UNITED STATES PATENT AND TRADEMARK OFFICE

APPLICATION NO.	FILING DATE	FIRST NAMED INVENTOR	ATTORNEY DOCKET NO.	CONFIRMATION NO.
10/724,754	12/02/2003	Etienne Galmiche	0512-1190	1809

Office Action Summary

Figure A. Prior art of Schroter.

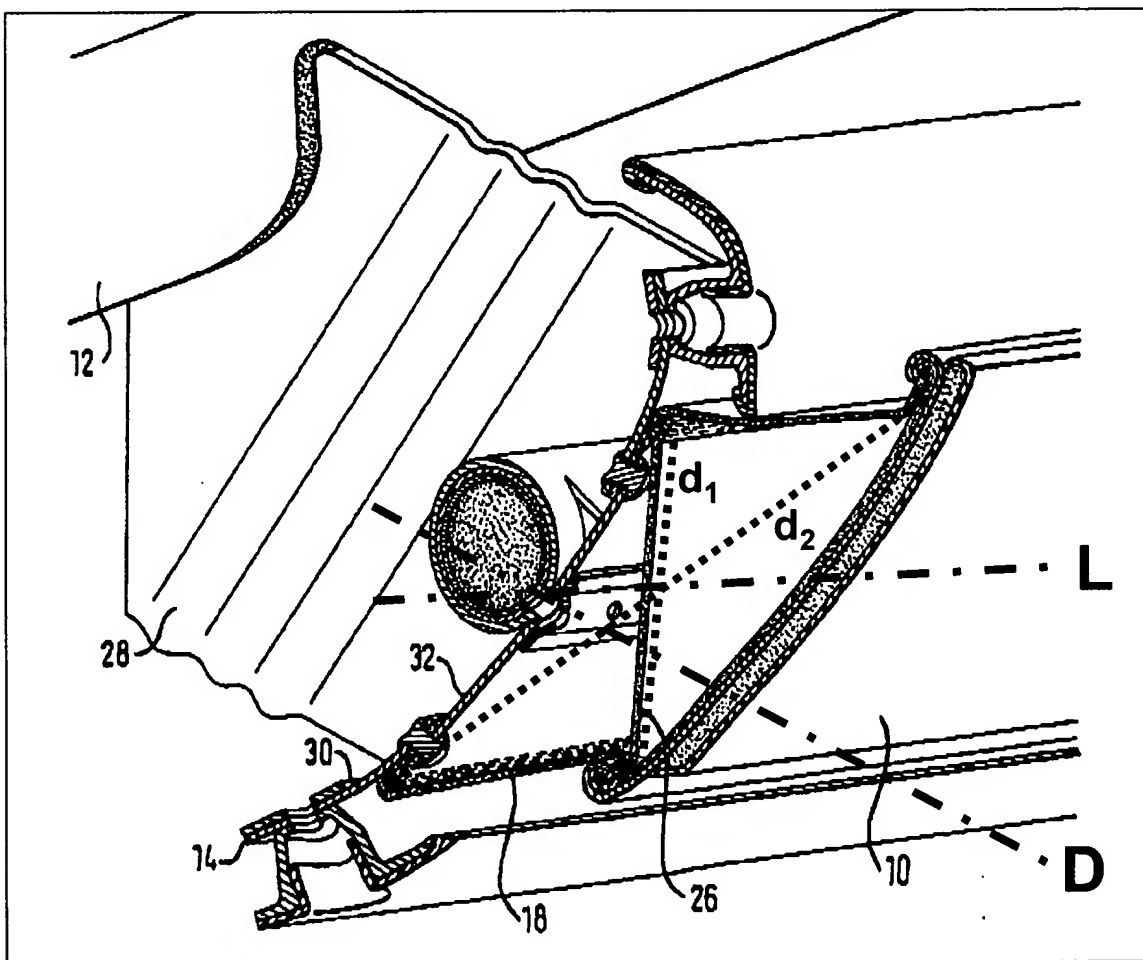
5. Claims 1, 2, and 4-6 stand rejected under 35 U.S.C. 102(b) as being anticipated by U.S. 6,131,950 to Schroter. Schroter discloses a knee restraint for vehicles comprising the following:

- a. An inflatable structure comprising a side wall 18 and an end wall, the inflatable structure having a folded configuration and a deployed configuration, a support 30 for the inflatable structure, means 16 for inflating the structure in a

direction of inflation in order to deploy it, a plate 10 for spreading the load when an occupant of the vehicle impacts on the deployed inflatable structure, means of guiding the structure as it deploys so that, in the deployed configuration, the structure extends along a median directrix line distinct from the direction of inflation wherein the guide means comprise the side wall 18 of the structure which, in the deployed configuration, is substantially taut as shown in Figure A below (claim 1.)

b. The side wall 18 of the structure has a first diagonal d_1 shorter than a second diagonal d_2 of the side wall so that, as the structure deploys, the side wall which is substantially taut along the first diagonal brings the structure towards the median directrix line as shown in Figure A below (column 1, line 56 – column 2, line 11) (claim 2.)

c. When the structure is in the deployed configuration, the side wall 18 extends substantially over its entire periphery along generatrices parallel to the median directrix line L as shown in Figure A below (Fig. 4) (claim 4.)

- d. The median directrix line L is intended to be inclined upwards with respect to the direction of inflation D when the set of equipment is installed in a motor vehicle as shown in Figure A (Fig. 4) (claim 5.)
